701 DEXTER AVENUE N, SEATTLE WA 98109

WEST DESIGN REVIEW BOARD
EARLY DESIGN GUIDANCE
EDG 2 MEETING DATE: 07.10.19
SDCI #: 3033099-EG

04 MATERIALITY | Context Character

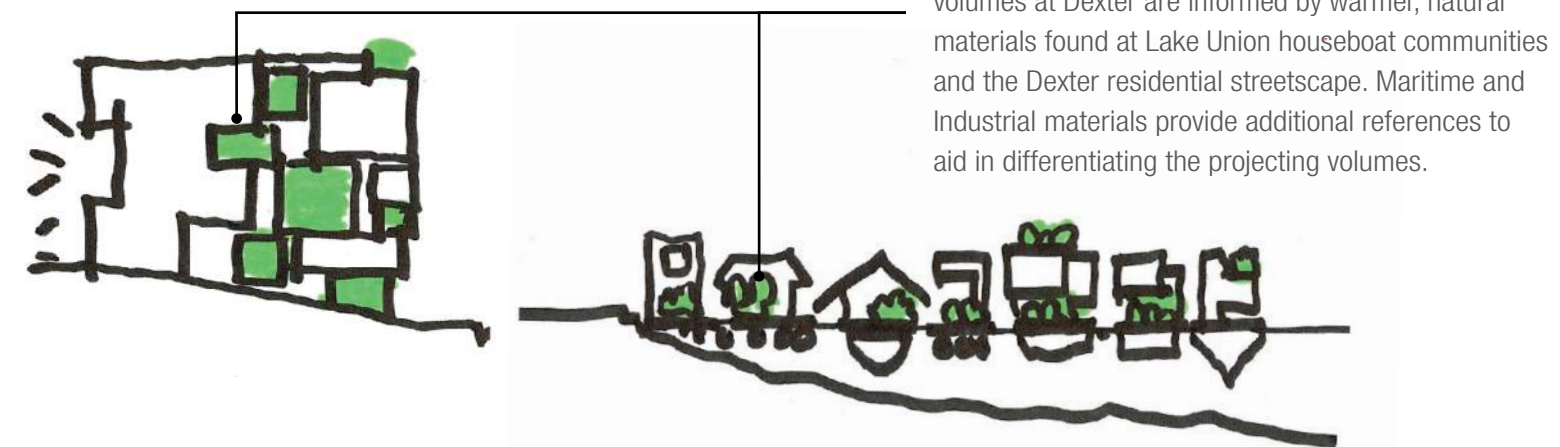
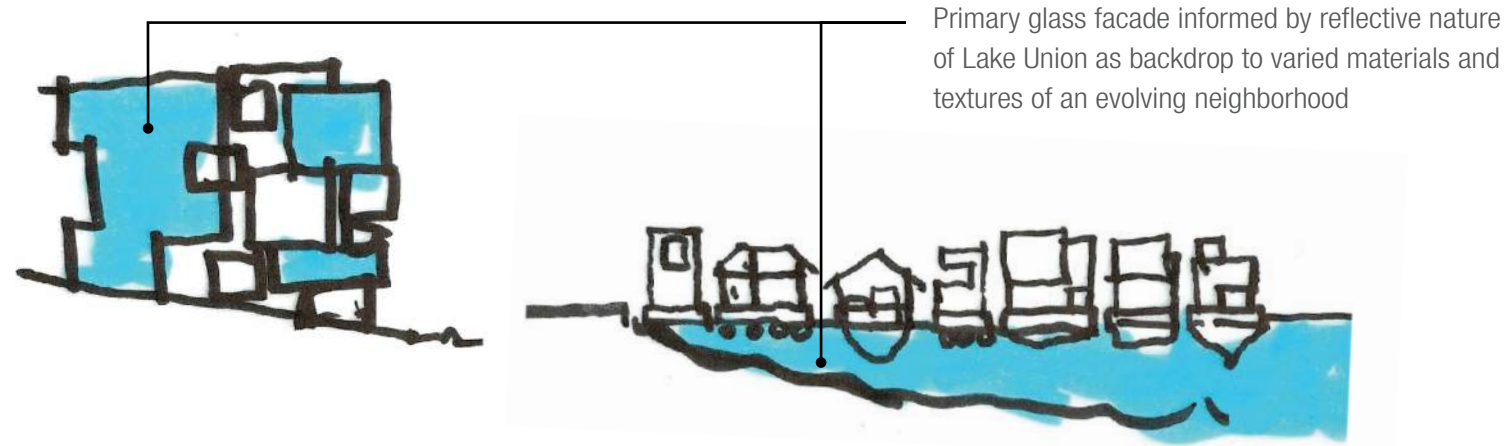
C.1 Further clarify the design intent related to materials and facade articulation

C.3 Note how the building will differentiate itself from similarly clad buildings.
